Service Letter SL No. 49 R9	DOA No. EASA.21J.020
--	--	-------------------------

Planning Information

Re-Positioning of de-ice cables to improve long time wear. During the next inspection/repair or overhaul the de-ice cables should be re-oriented to reduce the wear.

1. MTV-27-1-N-C-F-R(P)/CFR260-65a installed on Pilatus PC 12 with spinner assembly P-1059-():

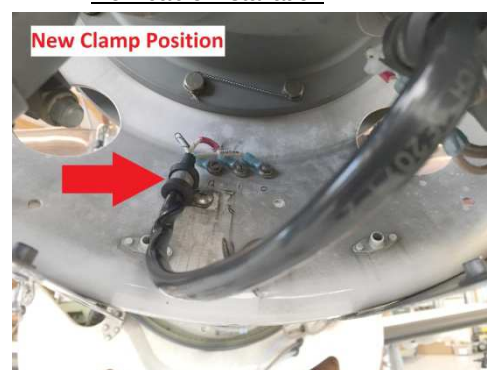
- ✦ Clamp on the connectors according to the picture New Clamp Position.
- ✦ Check de-ice cable length (New part number de-ice cable **4E2071-2** or **4H2071-2**)
- ✦ The 10 spinner screws C-306-8 (AN526C1032R8; overall length 15 mm/0,59 inch) used to mount the filler plate
to the spinner dome between front and rear spinner bulkhead should be replaced by the 10 spinner screws C-306-7 (AN526C1032R7; overall length 13,72 mm / 0,54 inch) that they do not protrude the self locking nut which can wear out the de-ice cable.

New cable installation on counterweight body

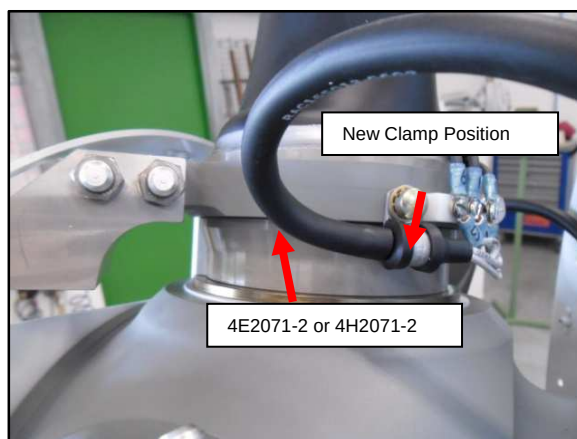
Continued 1.

Fig. 2

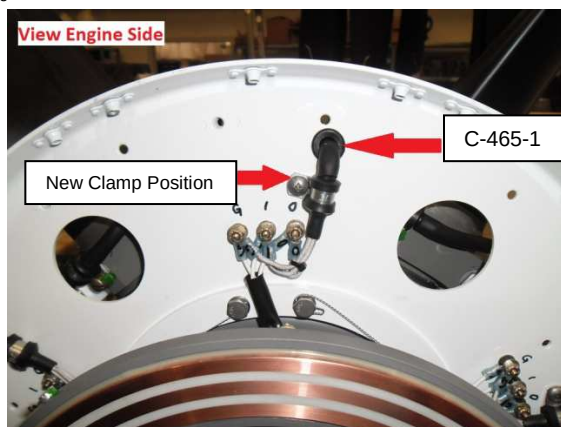
1. To reposition the clamp make a new 0,433"(11 mm) bore ; 0,393"(10 mm) left from the old cable clamp location and 0,984"(25 mm) rectangulaire high as shown in Fig.1 .
2. Deburr the new bore and install rubber protection C-465-1 .
3. Install clamp with cable at new location (Engine Side) according the picture on the right side of the cable connectors(Engine Side) as shown in Fig 2.

Or optional improved cable installation with 4E2075-2 cable and C-151-1 clamp

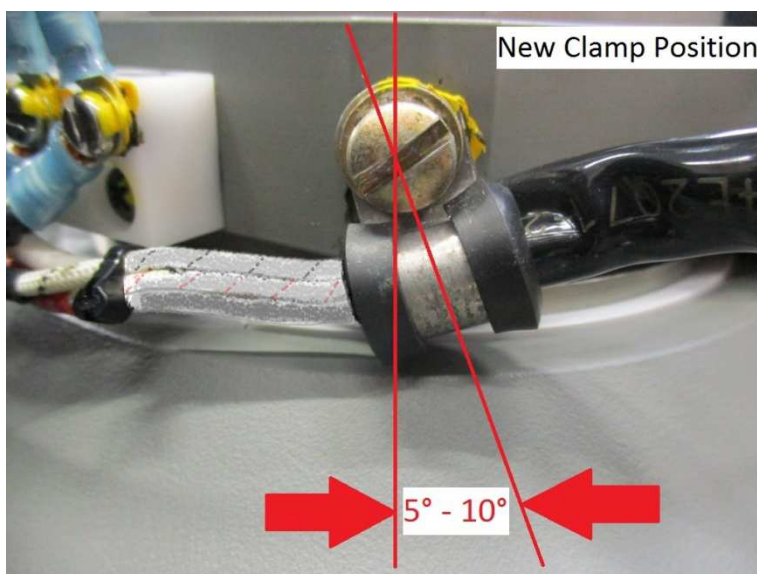
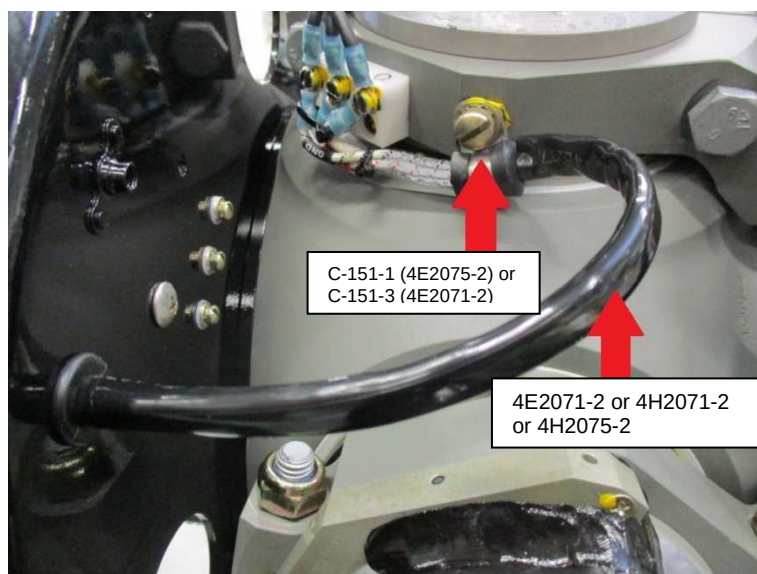
The removed vulcanized rubber on one side of the wire 4E2075-2 will give the cable on the counterweight side more flexing and can improve the life time.

Note: The new clamp position is applicable on all cable types.

Or optional improved cable installation with 4E2075-2 cable and C-151-1 clamp

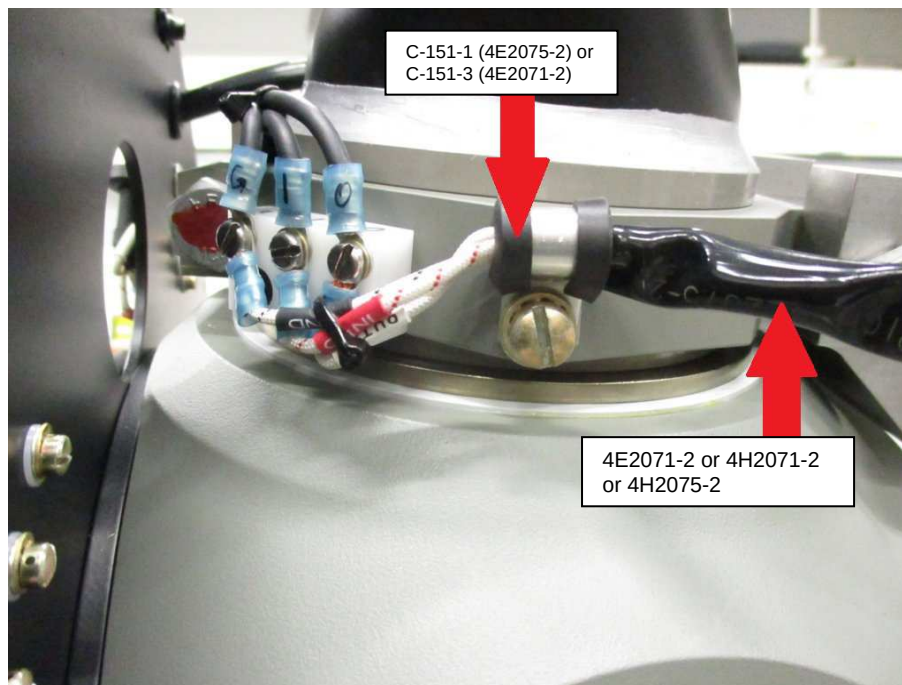
The removed vulcanized rubber on one side of the wire 4E2075-2 will give the cable on the counterweight side more flexing and can improve the life time.

Note: The new clamp position is applicable on all cable types.

Fig.6

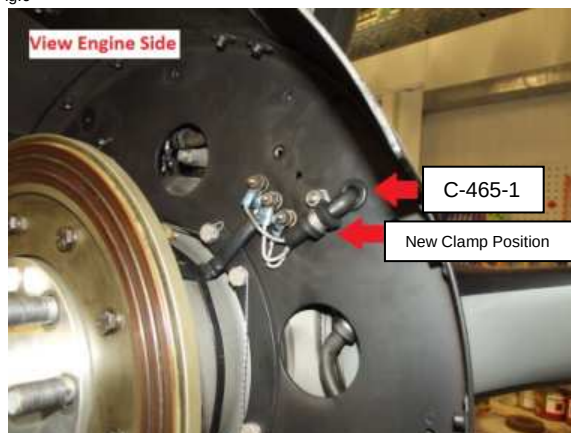
1. To reposition the clamp make a new 0,433"(11 mm) bore ; 0,590"(15 mm) left (CFRL Application)/right (CFR Application) from the old cable clamp location and 0,629"(16 mm) rectangulaire high as shown in Fig.5 .
2. Deburr the new bore and install rubber protection C-465-1 .
3. Install clamp with cable at new location (Engine Side) according to Fig 6.

Or optional improved cable installation with 4E2075-2 cable and C-151-1 clamp

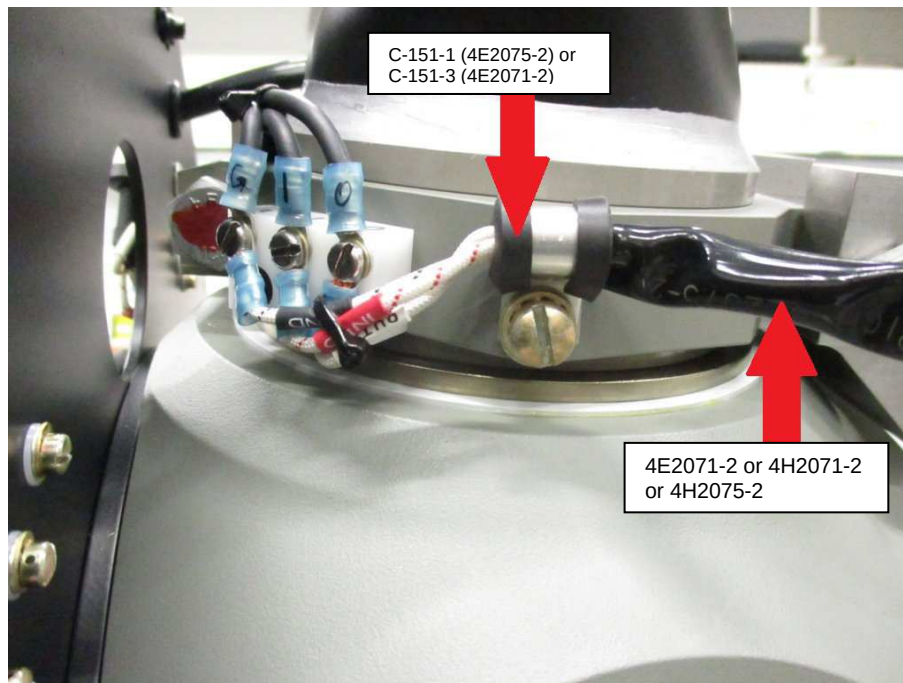
The removed vulcanized rubber on one side of the wire 4E2075-2 will give the cable on the counterweight side more flexing and can improve the life time.

Note: The new clamp position is applicable on all cable types.
